**CHARTER TOWNSHIP OF VAN BUREN
PLANNING COMMISSION AGENDA
Wednesday, May 9, 2018 – 7:30 PM, Board of Trustees Room**

ITEM #1: CASE 17-036 – FINAL SITE PLAN APPROVAL

RE: Case 17-036 Constellium Addition Final Site Plan Review

Re: Constellium Facility Expansion
6331 Schooner Drive
Belleville, MI 48111
Construction and Final Site Plan Approval

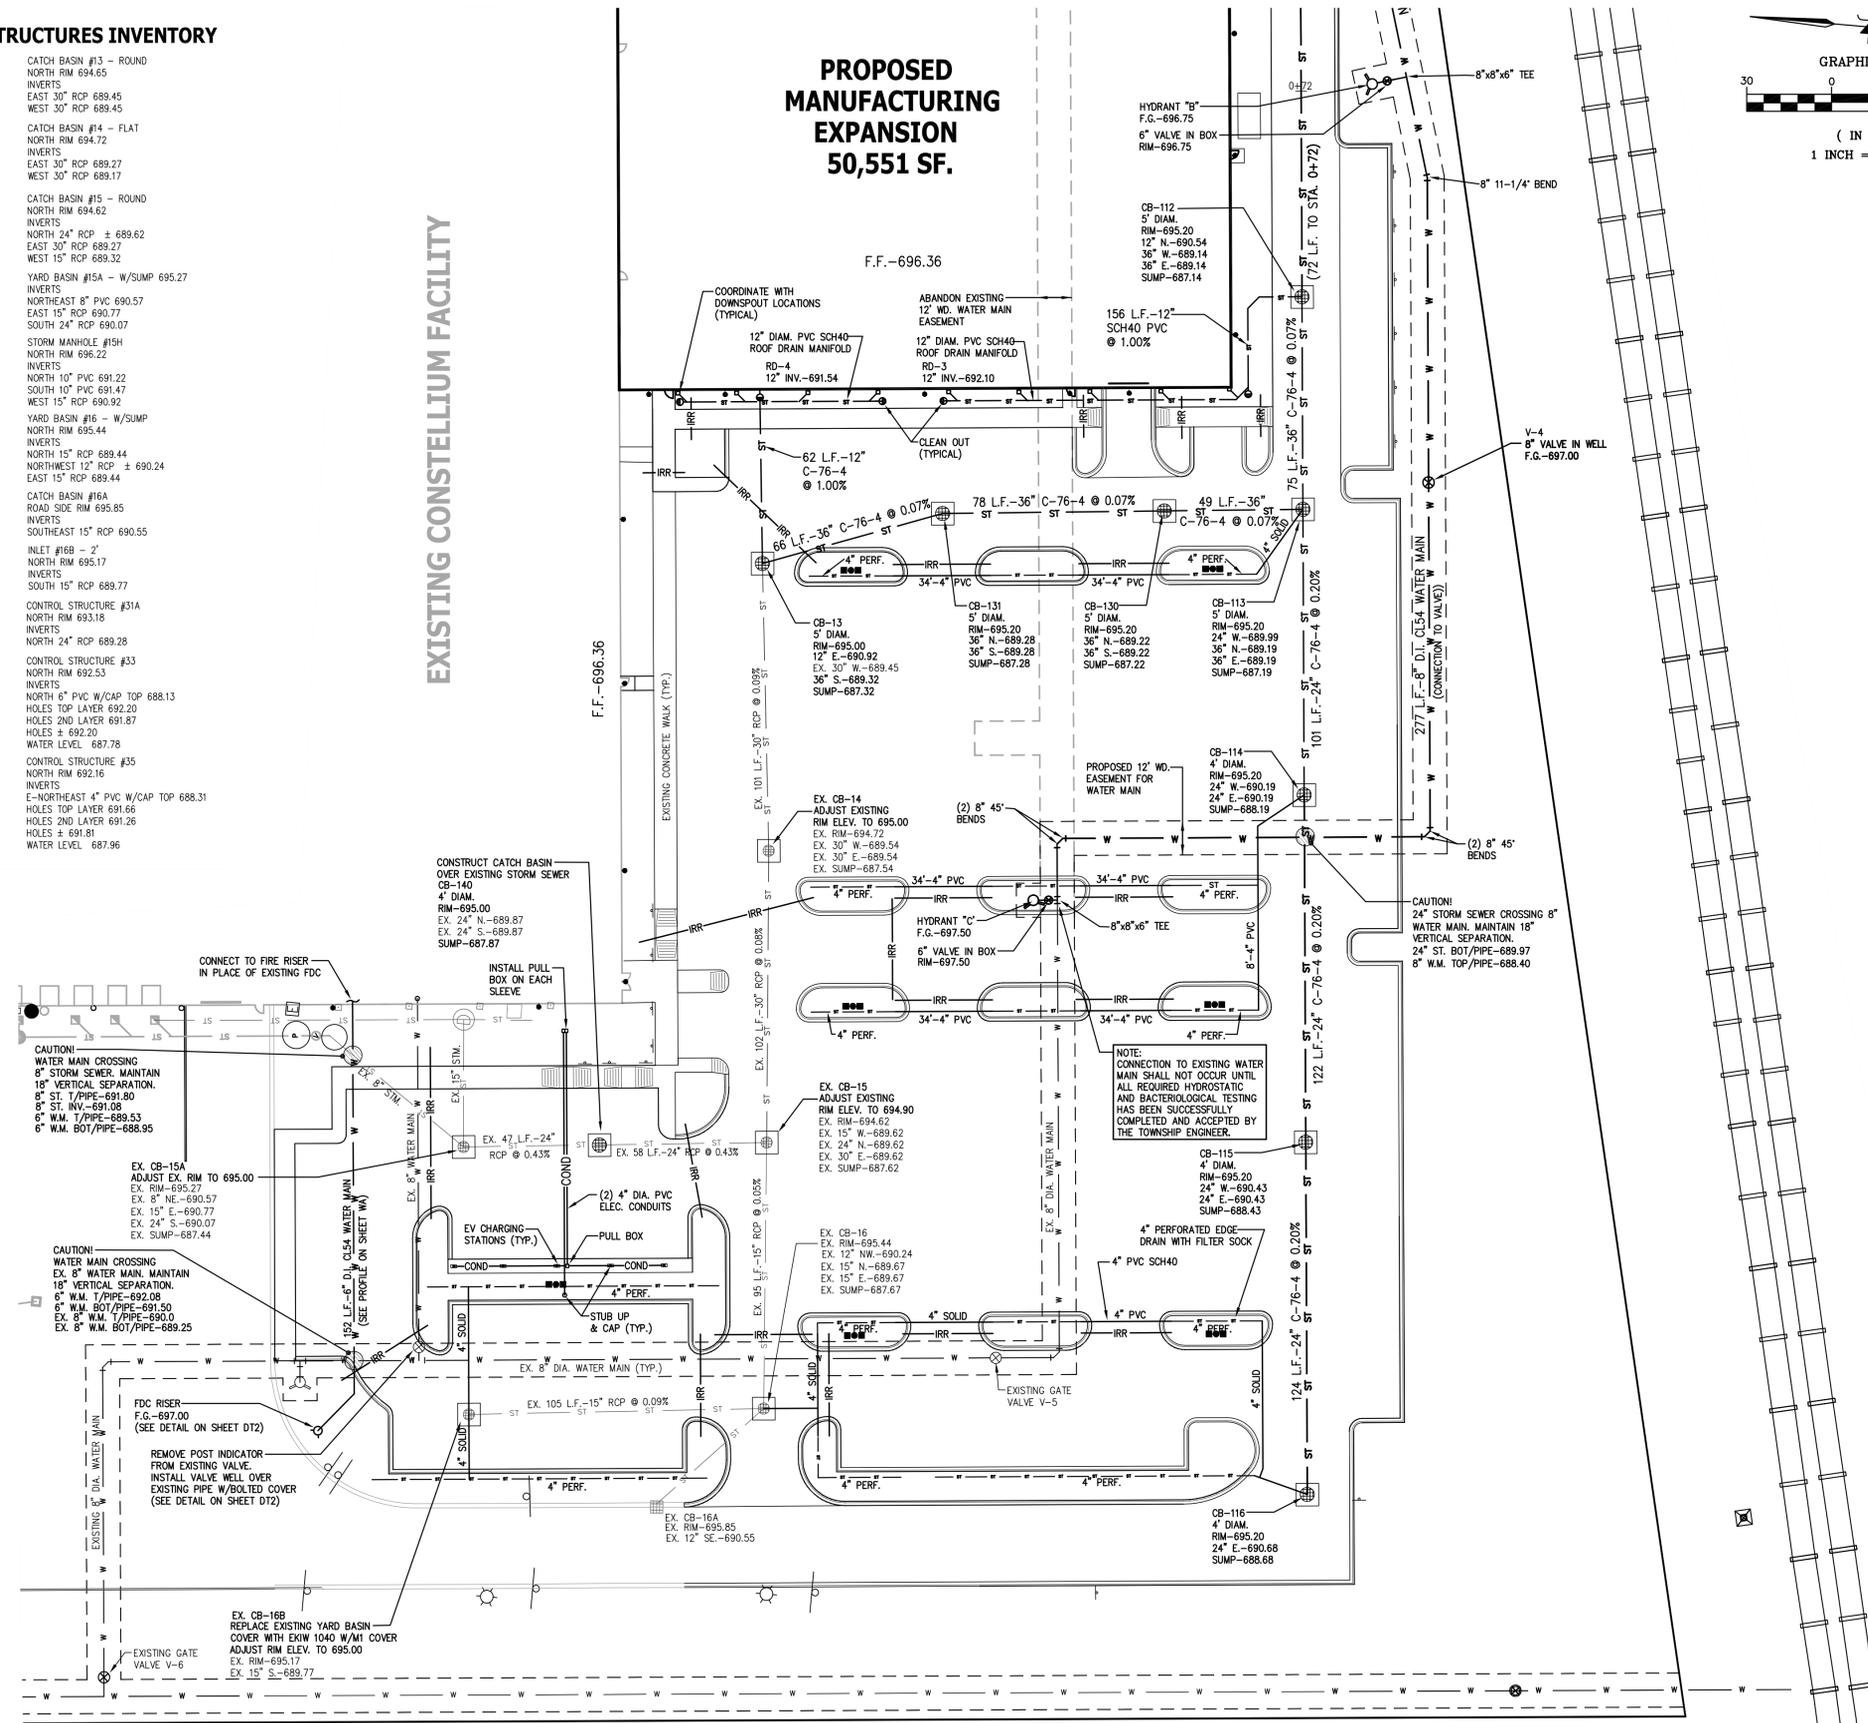
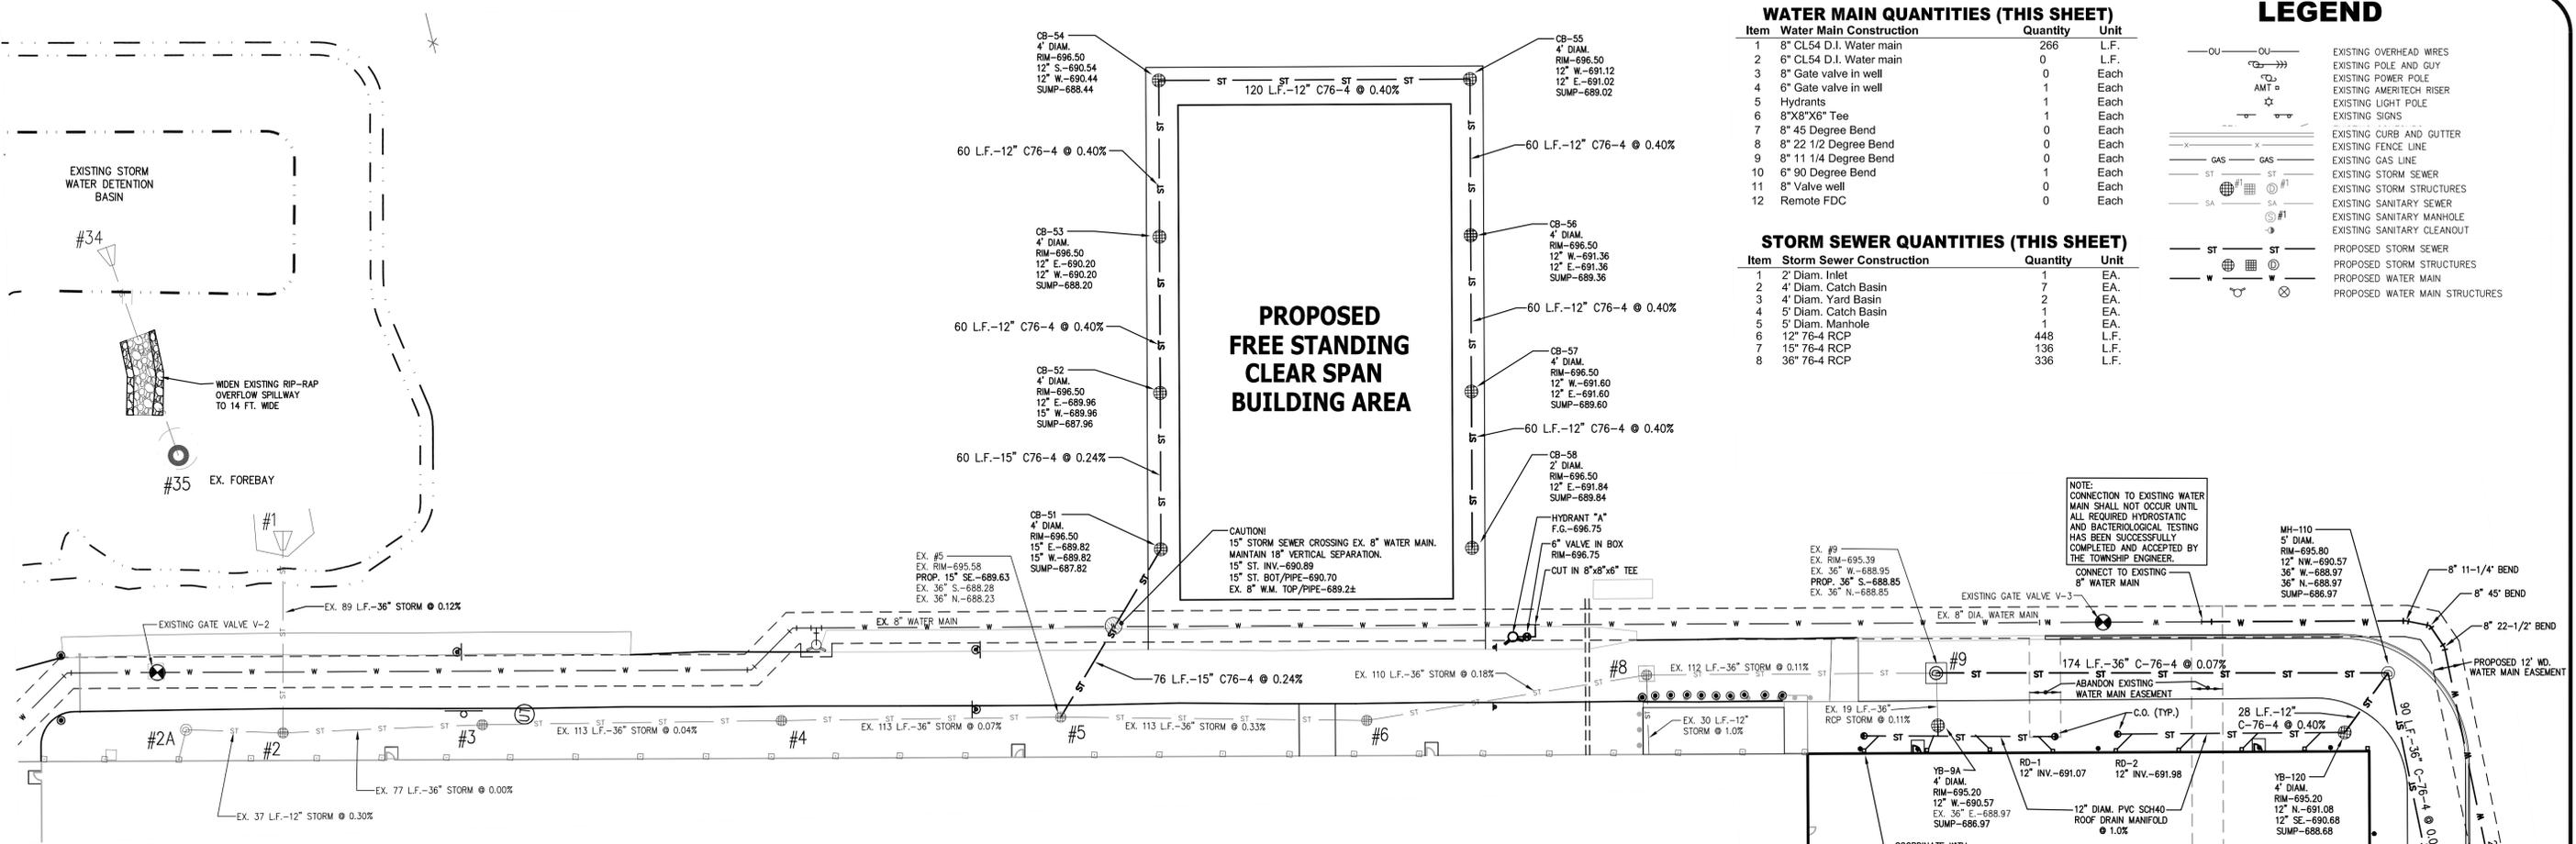
1. *(Previous Comment No. 5) PR: Storm sewer size is indicated incorrectly on the profile for 36-inch sewer between CB-13 and CB-131. It measures as 30 inches, but should be a 36 inches.*

REMOTE FDC PROFILE
 SCALE: HOR. 1"=30' / VERT. 1"=3'

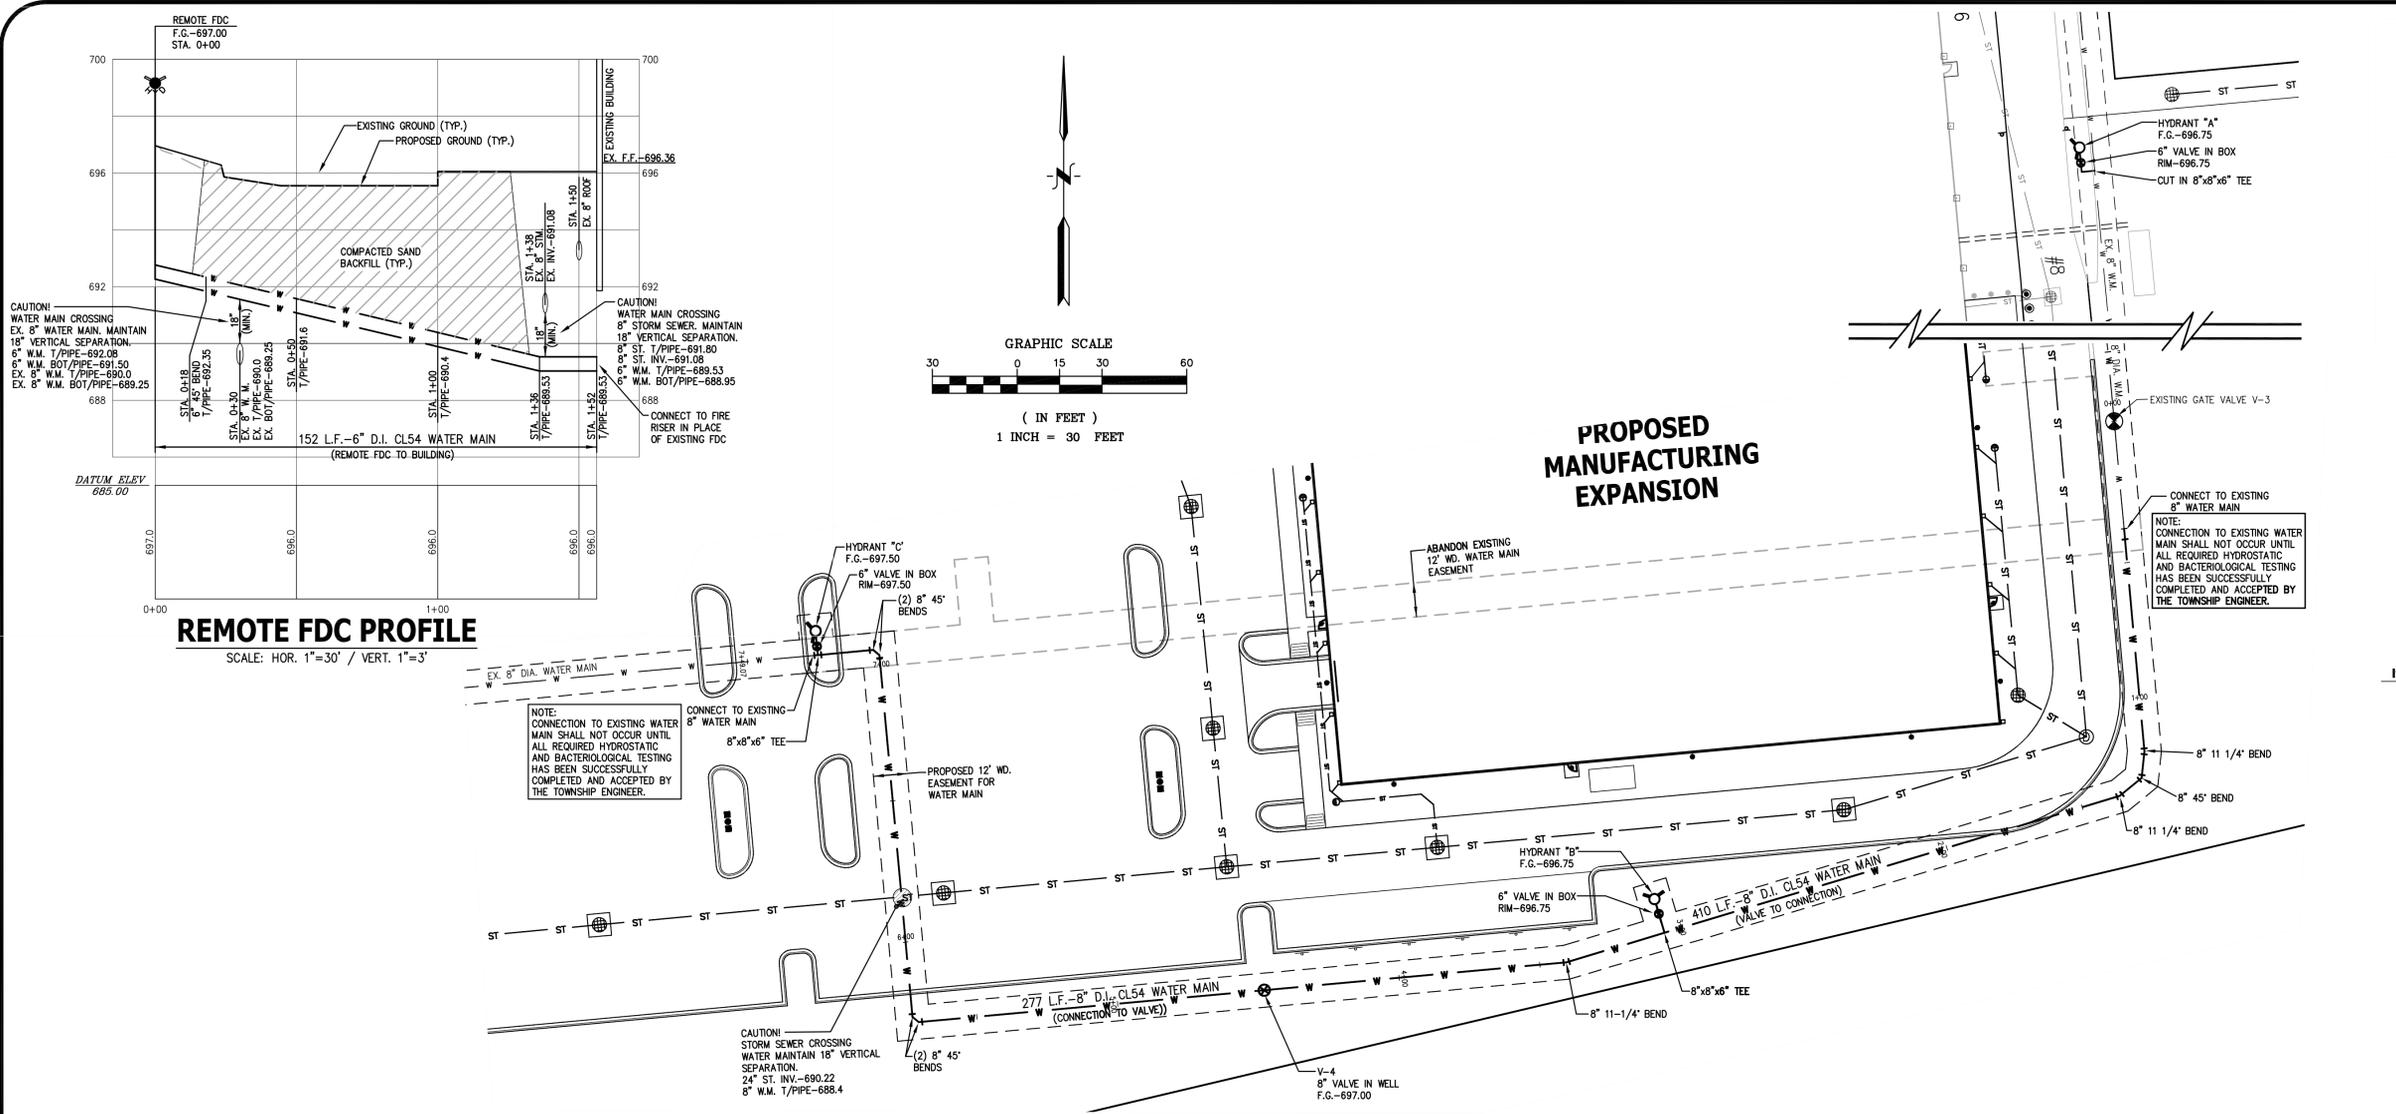
- ~~1. Hydrant that is located next to remote FDC is not shown on plans.~~
2. **NFPA 1 2012 11.10.1 In all new and existing buildings, minimum radio signal strength for fire department communications shall be maintained at a level determined by the AHJ.**
